CITY OF VINCENT

Council Briefing

13 September 2022

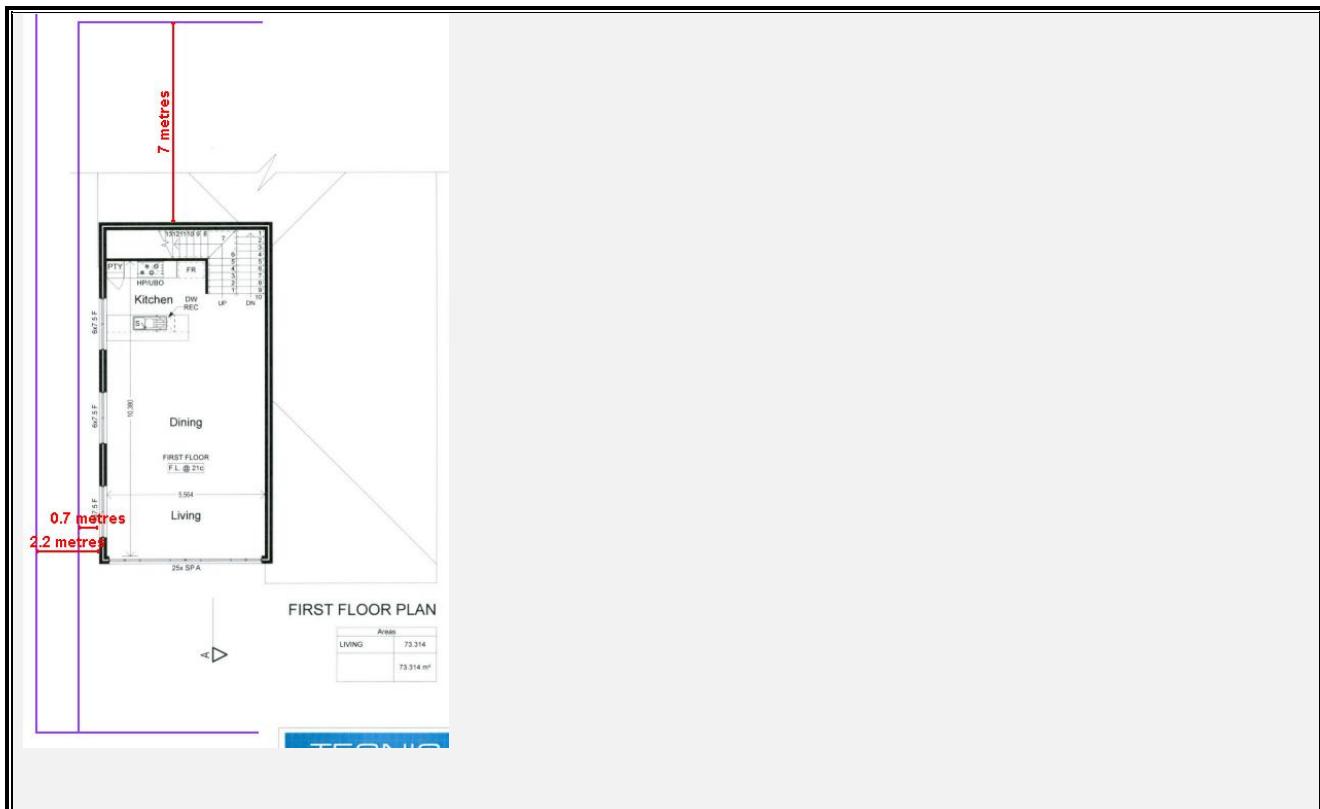
Please provide clarification on the lot boundary setbacks that have been provided.

The R Codes provide the following deemed-to-comply setbacks to the northern boundary:

- 1.2 metres for the first floor; and
- 1.4 metres for the second floor.

The first and second floors propose a setback of 7 metres to the northern lot boundary to No. 166A Chelmsford Road.

Indicative image of verge tree canopy at a 20 metre maturity at the subject-site:

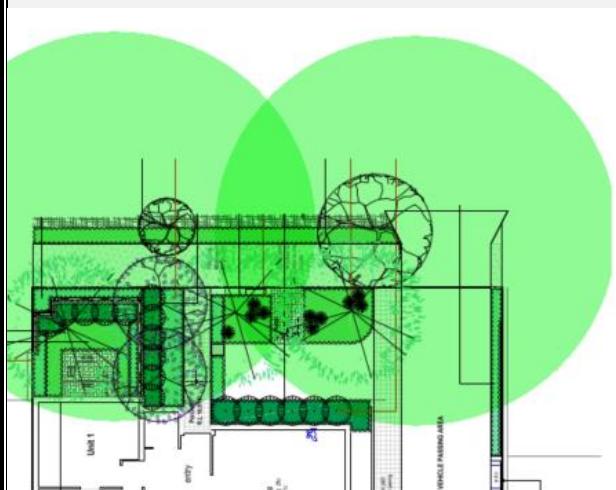
The City's Parks team have noted that the canopy coverage of the existing verge trees to Summers Street are not accurately demonstrated on the site plans.

Vertical Cone of Vision Diagrams 103 – 105 Summers (Child Care Centre)

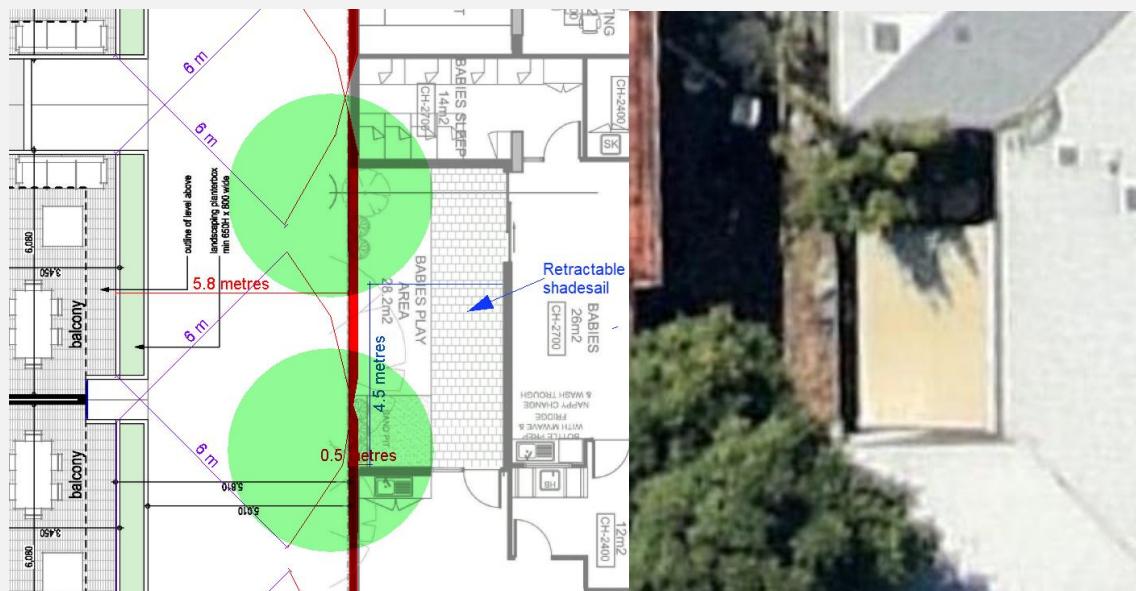
The existing development to the west has floor to ceiling windows. The setbacks to the new development are reduced. Are there issues with bulk and privacy issues because of this?

Administration have prepared visual privacy diagrams to demonstrate how the development relates to the child care commercial land use.

The diagrams demonstrate that the development would not have adverse amenity, privacy and shadow impacts on the child care centre.
